Clinch River Nuclear Site
NRC Docket No. 52-047

Subject: Response to Request for Additional Information RAI Number 3, eRAI-8893,
Regarding Vibratory Ground Motion in support of Early Site Permit Application for
Clinch River Nuclear Site

Response to NRC Request for Additional Information Number 3, eRAI-8893

Attachment 1
SSAR Subsections 2.5.2.5, 2.5.2.5.1.1, and 2.5.2.6 Markups

Figure 2.5.2-107. Comparison of 1D (Base-Case Profile) and 2D Amplification Factors (PSA, 5% Damping) for Location A

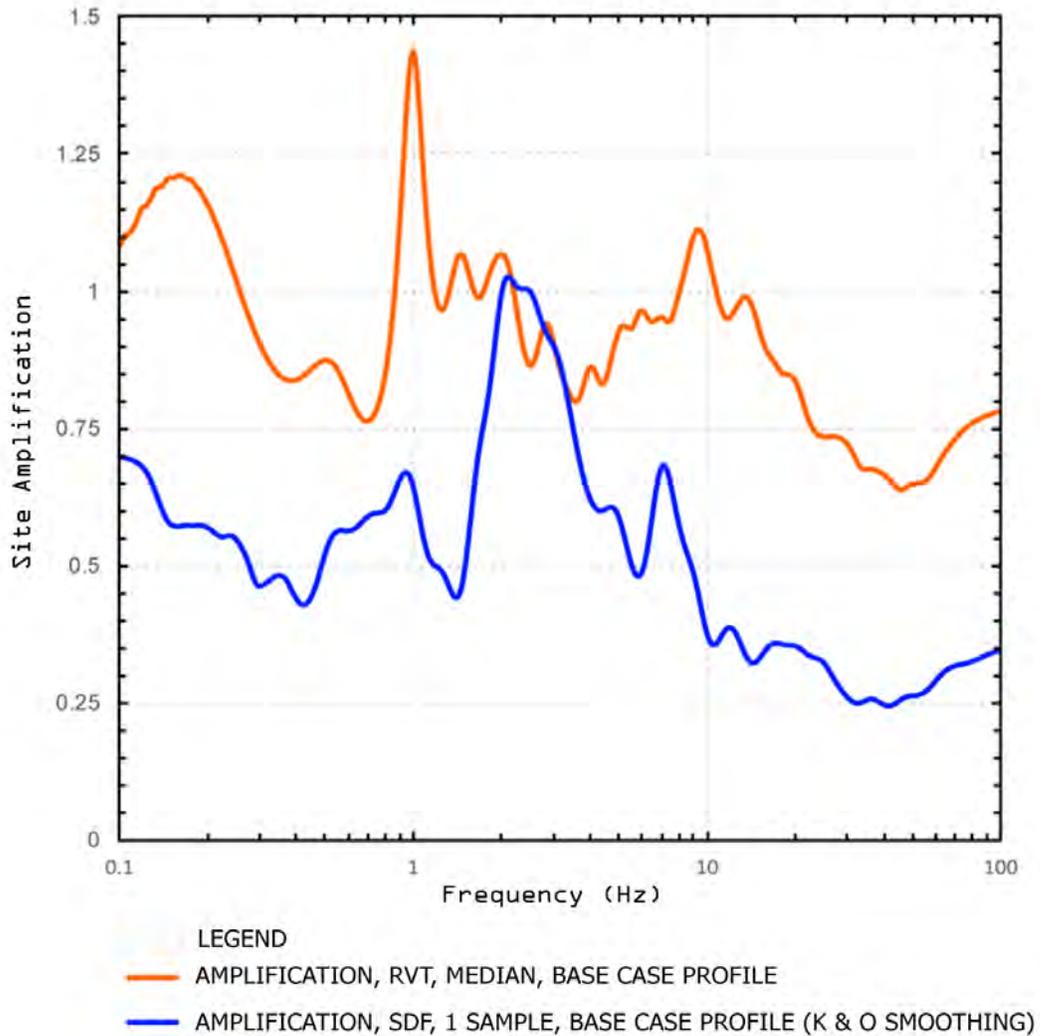
Section 2.5.2.6 of the SSAR provides the results of a sensitivity study evaluating the potential impact of 2-D site effects on site response. This sensitivity study includes a comparison of the 2-D site response and a 1-D site response using a similar approach used for the 2-D results. However, the 1-D site response used in this comparison is not used for establishing the permit basis of the Clinch River site. The comparison presented in the SSAR does not currently show that the 1-D site response used for licensing adequately captures the 2-D site effects explored by the sensitivity study.

In order to satisfy requirements in 10 CFR 100.23(d)(1) as it relates to seismic hazard and for the staff to make a determination about the adequacy of the 2-D sensitivity study, please provide a comparison of the 2-D site response to the 1-D site response results used to establish the Clinch River site GMRS.

SSAR Subsection 2.5.2.6, "2D Sensitivity Analysis," is being revised to provide additional detail regarding the 1D amplification used in the development of the Clinch River GMRS as compared to the 2D sensitivity analysis. Additionally, Figures 2.5.2-107, 2.5.2-108, 2.5.2-109, and 2.5.2-110 are being added to detail the comparison of the 1D base case profiles to the 2D amplification factors for Locations A and B. The overall conclusions regarding 2D effects for the Clinch River Site have not changed. See the SSAR markups provided in Subsection 2.5.2.6 in Attachment 1.

Figure 2.5.2-107 compares the 1D amplification used in developing the GMRS with the 2D sensitivity analysis for Location A. In Figure 2.5.2-107 the 1D amplification factors shown are for the base-case profile and reflects the median estimate over 60 realizations. Since the 2D sensitivity calculation represents only a single analysis or realization, it has been smoothed using the Konno and Ohmachi algorithm (Reference 2.5.2-211) to reflect similar resolution as the 1D median estimate.

As Figure 2.5.2-107 illustrates, the 1D amplification factors significantly exceed the smoothed 2D factors computed in the sensitivity analysis across all frequencies except for a narrow frequency range around 2 Hz. Figure 2.5.2-108, illustrates the broadening of the 1D amplification by including the median amplification for the lower- and upper-range profiles.
